**MEMORANDUM TO CITY OF ASHEVILLE FROM  
SAM SCHWARTZ CONSULTING, LLC**

To: Ken Putnam, City of Asheville  
From: Sam Schwartz Consulting, LLC  
Date: September 19, 2018  
Re: I-26 Connector Project, Final FEIS Technical Memorandum  
STIP: I-2513

Figure 9: Conceptual drawing of SB I-26 ramps with Patton Avenue with alternative (black) ramps that could replace the original Alternative 4-b alignment (orange) and the remaining NCDOT proposed alignment (white)

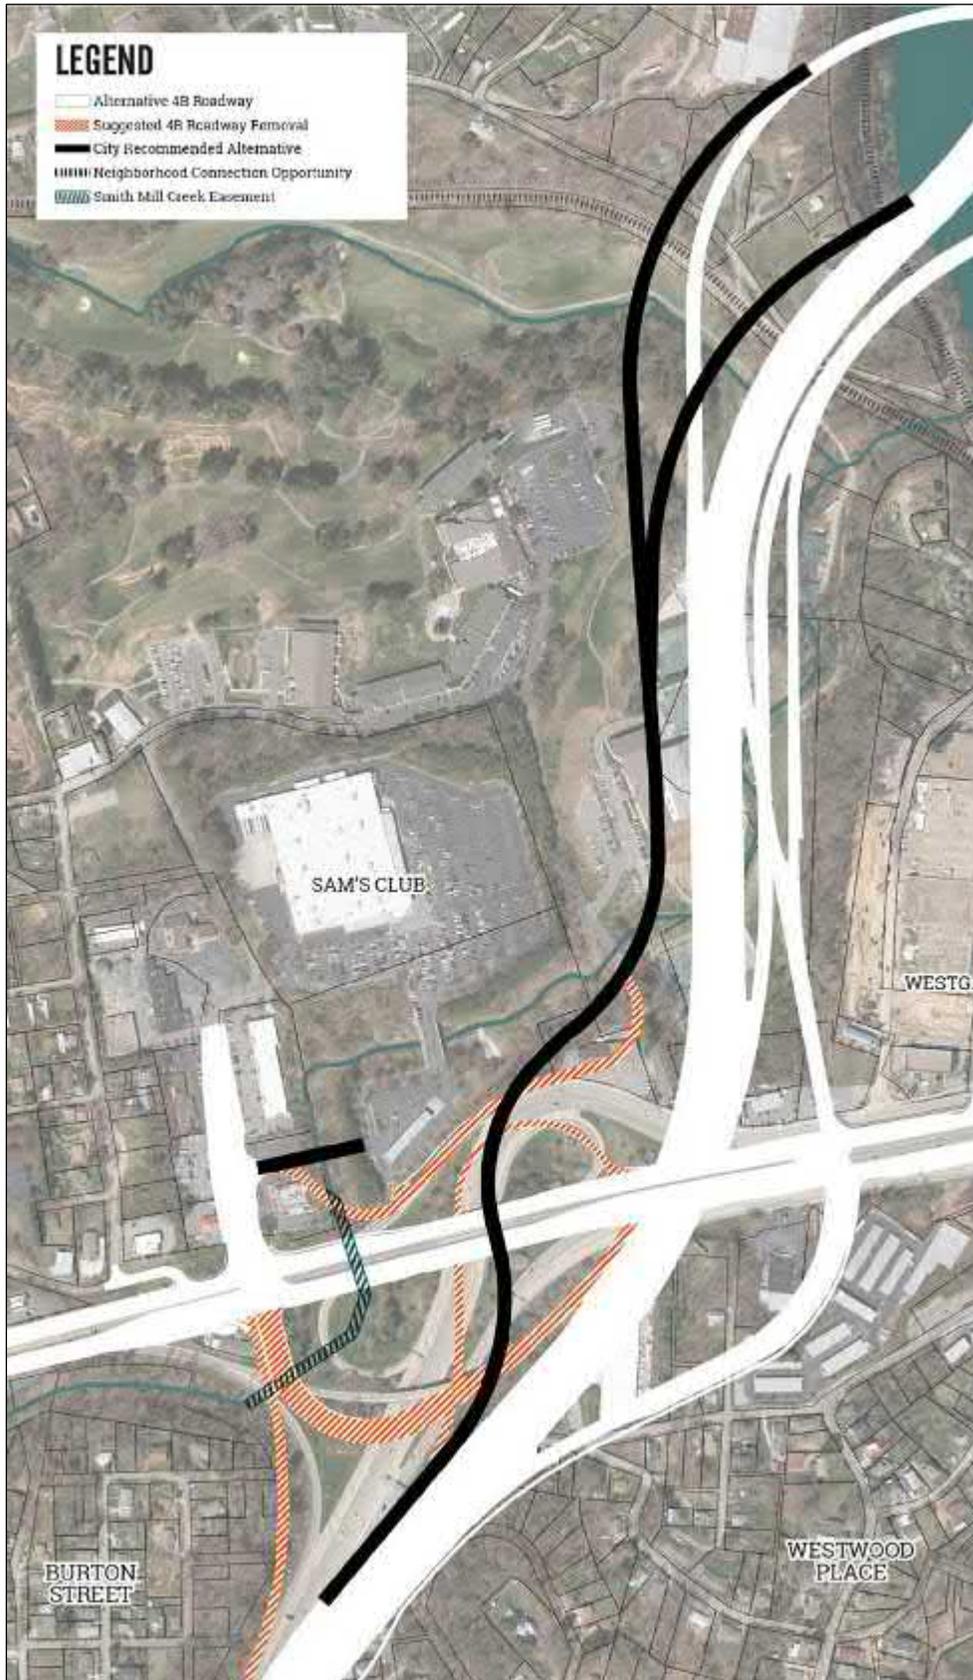
A potential alternative concept for the interchange of I-26, I-240, and Patton Avenue on the west side of the French Broad River is shown in Figure 9. This concept replaces the ramps as currently proposed with a more traditional diamond interchange, which NCDOT's consultant AECOM confirmed could be feasible from a preliminary geometric analysis within the project requirements for horizontal and vertical alignments. Due to vertical clearance requirements over the Blue Ridge southern railway adjacent to Emma Road, the I-240 WB Flyover elevations will increase approximately 10'-12' higher than the current (NCDOT) plan proposes. In order to maximize the use of the 8 acres of potentially disposable land, the control of access boundary may need to be modified through the standard NCDOT control of access adjustment process.

This alternative offers potential benefits including greater developable land and less highway ramp infrastructure around Patton Avenue, however it requires taking considerably more land in Emma, and the development potential of the parcels along Patton Avenue may be limited by the presence of the Smith Mill Creek. This alternative also has the possibility to provide traffic operations improvements, redirecting a currently-designed heavy left-turn movement from I-26 onto Patton Avenue into a proposed right-turn movement, increasing intersection capacity and throughput.

Both alternatives have significant benefits and drawbacks that require more study. The City recommends that both alternatives be kept in consideration through the design process.

Figure 10: Existing, NCDOT proposed, and City alternative design for the Captain Jeff Bowen Bridges

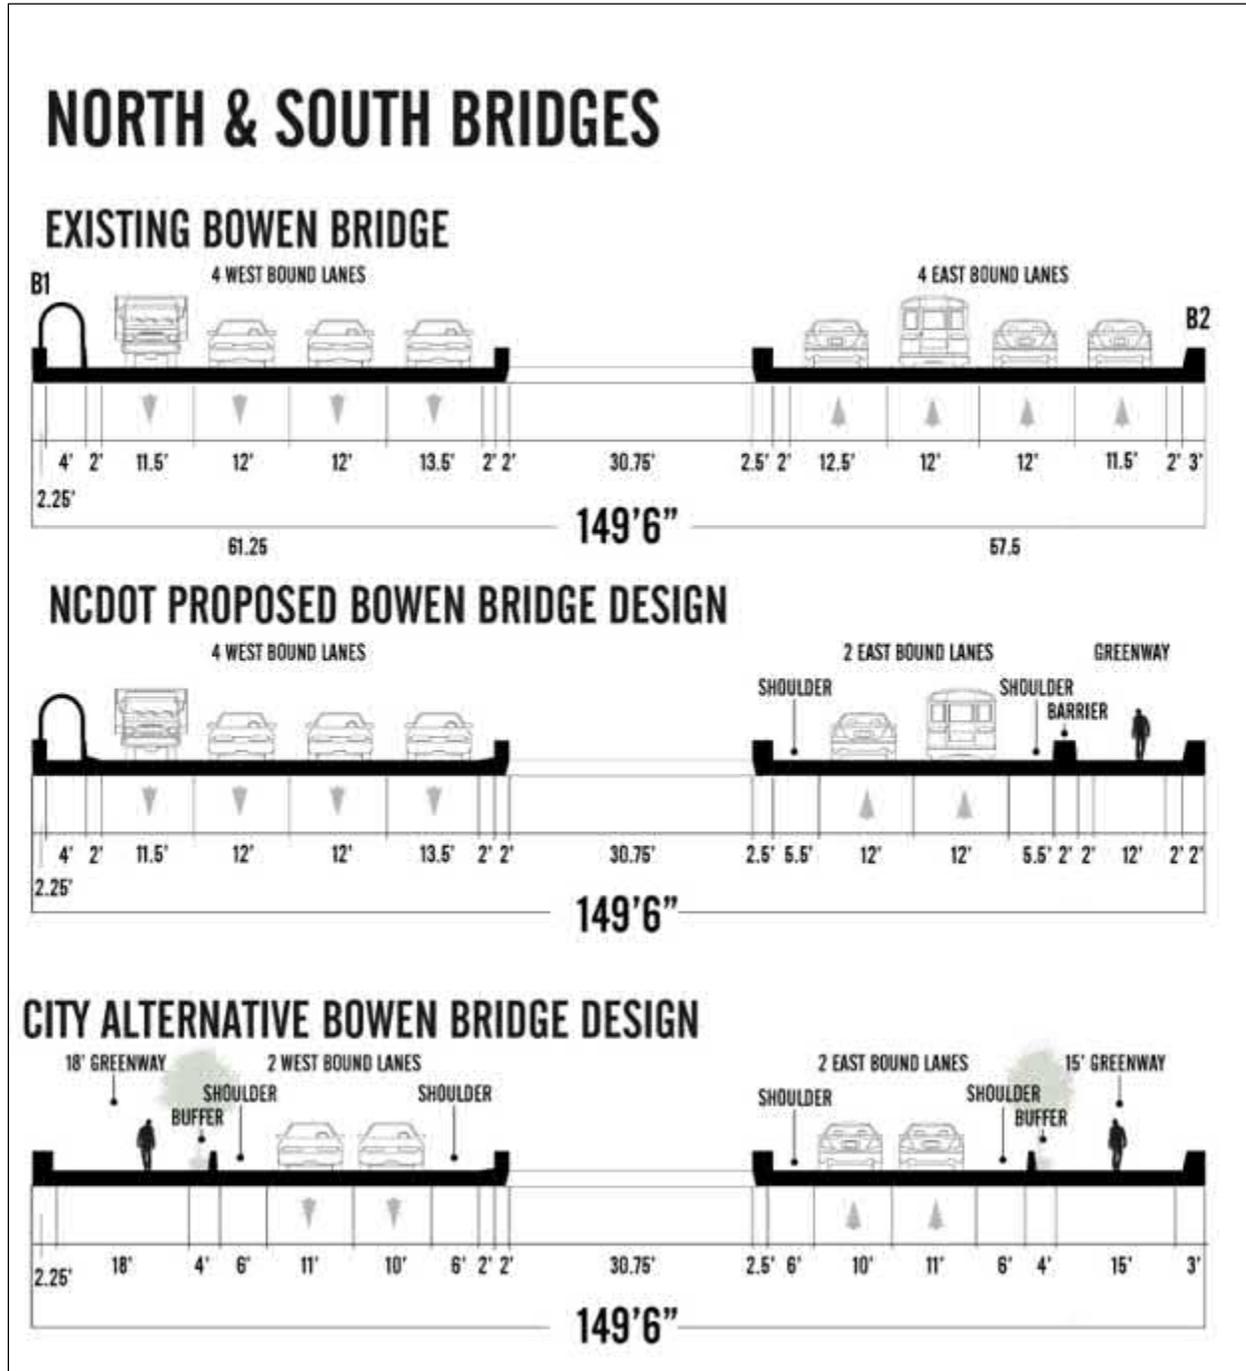
This alternative configuration has the key benefits of providing generous pedestrian and bicycle space on both bridges and calming traffic on this long stretch of roadway between traffic signals, while still being able to provide additional storage space to sufficiently accommodate queuing vehicles at the signalized intersections to the east and west of the Captain Jeff Bowen Bridges. AECOM has confirmed that the westbound bridge could theoretically be narrowed to 2 or 3 lanes but would likely have to widen to 4 lanes as it approaches the interchange with I-26/I-240. Further, while the state has committed to the multi-use path on the eastbound bridge, any such improvement on the westbound bridge may have to be paid for by the City.

As described above, the City recommends "right-sizing" the vehicular lanes on the bridges and creating pedestrian and bicycle connections over both spans of the bridge, per Figure 10.

**Figure 2 – NCDOT Design Concerns**

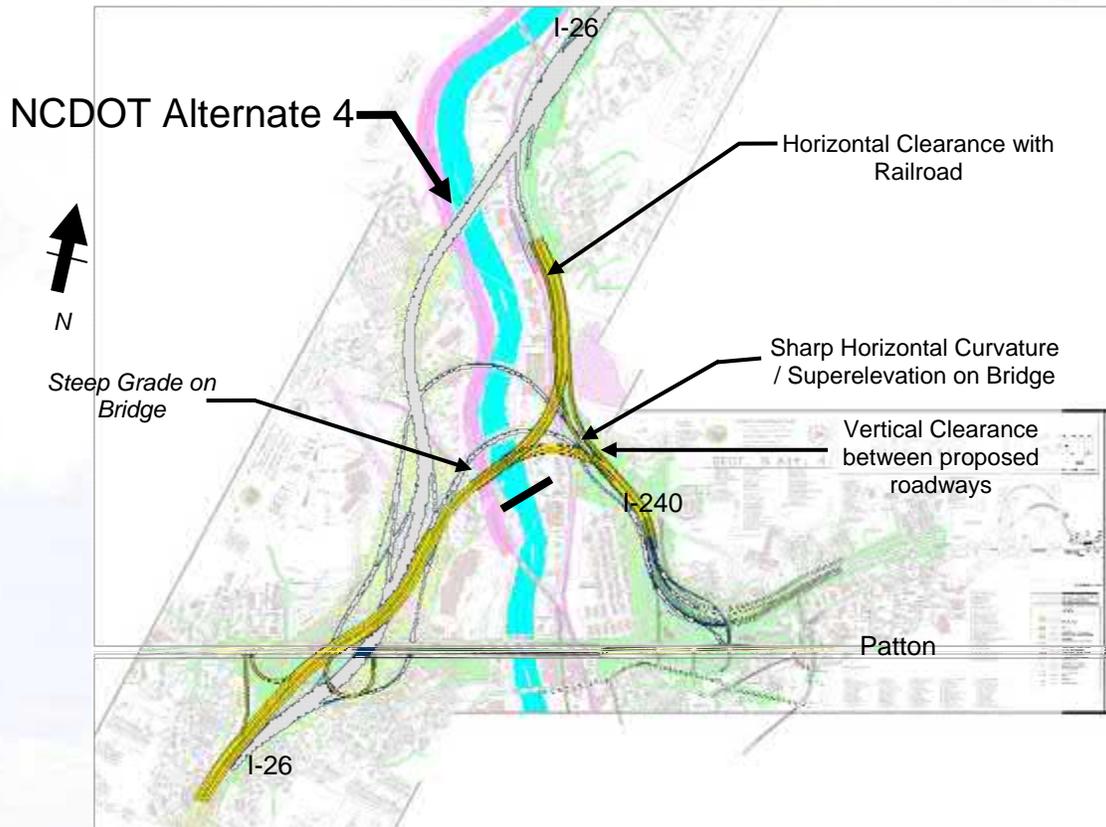
6. The grade on I-240 EB ramp (west side of river) required to provide the necessary vertical clearance over I-26 (at the double deck bridge) is acceptable. However, the profile on I-240 WB ramp (west side of river) required to provide the necessary vertical clearance over I-26 (at the double deck bridge) is not acceptable. Unlike the I-240 EB lanes, the I-240 WB lanes are at the low point of the 6% super-elevation prior to passing over I-26. This condition requires a steep grade approaching the double deck structure. There is also a low point on the structure which is unacceptable to the NCDOT. NCDOT does not allow sag profile low points on structures.

The following figures illustrate the major design, environmental and operational concerns raised by the NCDOT.

**Figure 4 – NCDOT Operational Concerns**

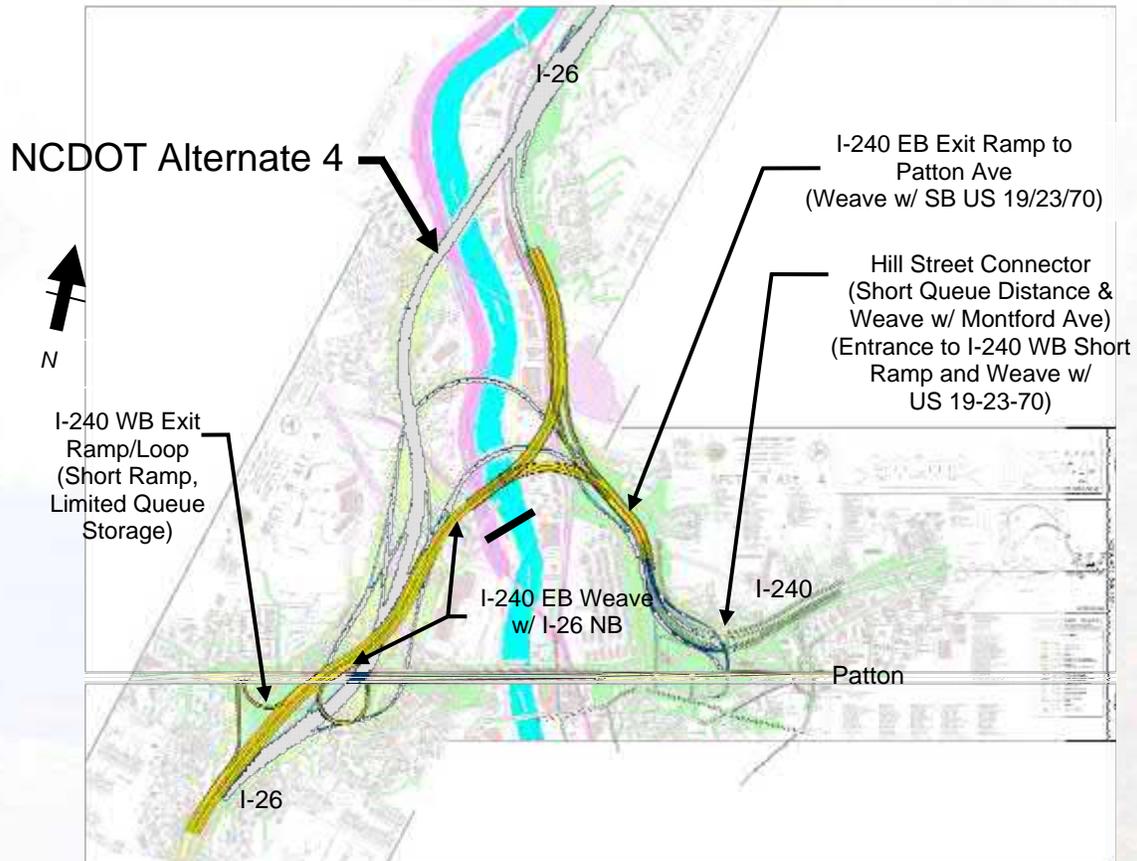
9. Operational issues (queue storage and weave distances) were identified as questionable at the following locations:
  - a. I-240 EB Exit Ramp to Patton

**Figure 16 – Alternative 4B Alignment Option 3  
(see appendix for 11" X 17" print)**

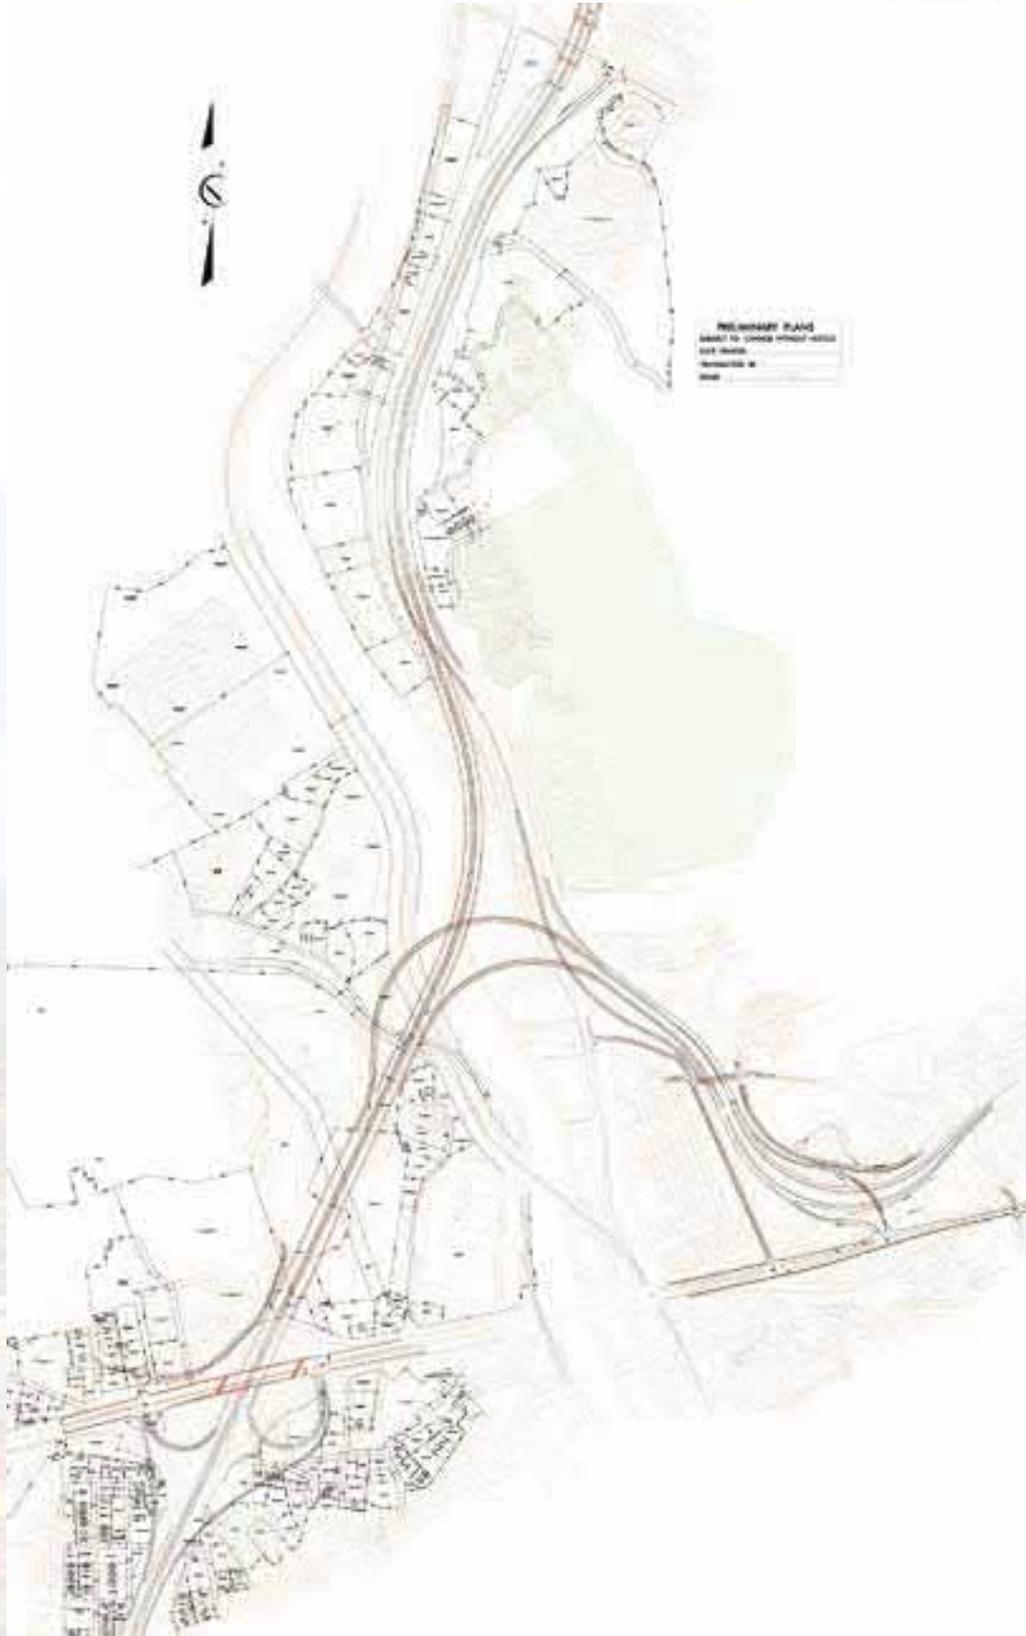
After reviewing these three options, the CA/BC and ADC offered the following comments:

1. **Option 1.** The CA/BC and ADC had previously looked at a similar tangent alignment west of the river and NCDOT had advised them that it may not satisfy constructibility. This option also has a larger footprint over the Freeman House Historic Property.
2. **Option 2 (preferred alternate).** It is consistent with their objectives by minimizing the footprint on the waterfront properties and is anticipated to have the most public support.
3. **Option 3.** This alignment does provide technical and environmental advantages over NCDOT alternates; however, most of the commercial business properties on the east side of the river are affected. Minimal public support for this alternate is expected.

**Figure 17 – Alternative 4B Braided Ramp Concept  
(see appendix for 11" X 17" print)**

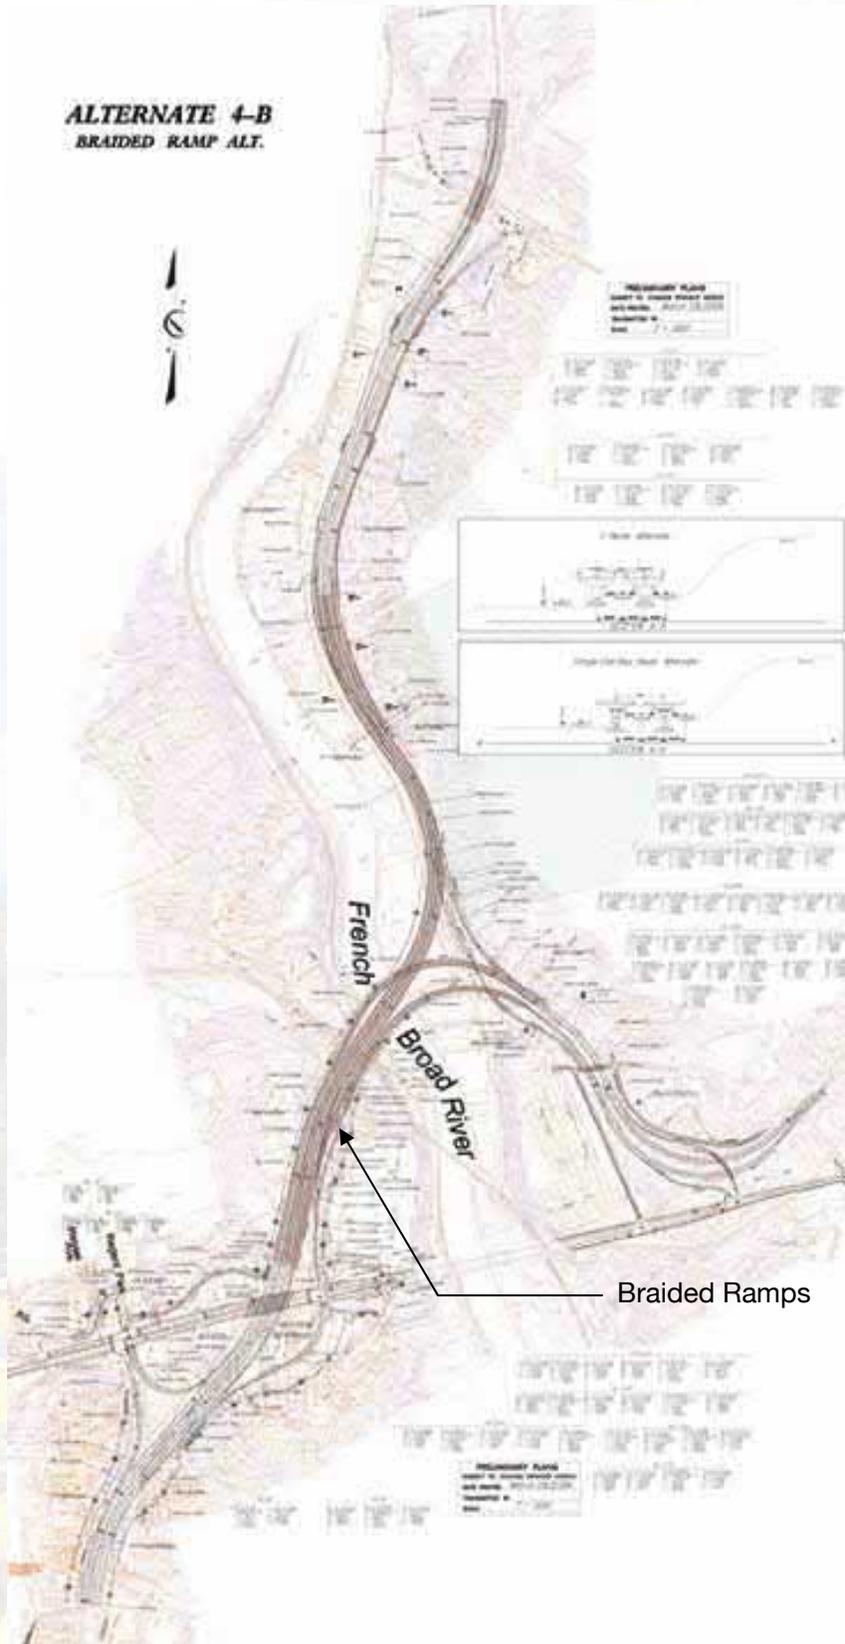
- None of the NCDOT alternatives provide all movements at all interchanges, but the movement that would not be included from Patton Avenue eastbound to I-26 northbound with this Alternative 4B is considered a primary required movement by NCDOT and FHWA.

- NCDOT was concerned with the length of the ramps before they split to I-26 and I-240 and stated that they felt a minimum of 1,000 feet was needed for decision making and to provide adequate signing.

- The FIGG Team will further address three potential solutions:
  - Braided ramp (also removing the sag on the bridge)
  - Add a loop to the interchange west of the river in the southeast quadrant
  - Provide the Patton Avenue EB to I-26 NB movement east of the river.
- After the FIGG Team revised and resubmitted the alternative, NCDOT would conduct a full review of the alternative.

After evaluating the three potential solutions discussed above during the comment resolution meeting of March 13, 2008, it was determined by the FIGG Team that the best solution was the braided ramp option. This solution consisted of:

This new revised Alignment 4B (see Figure 17) was submitted to the NCDOT on March, 28, 2008 for their continued review.
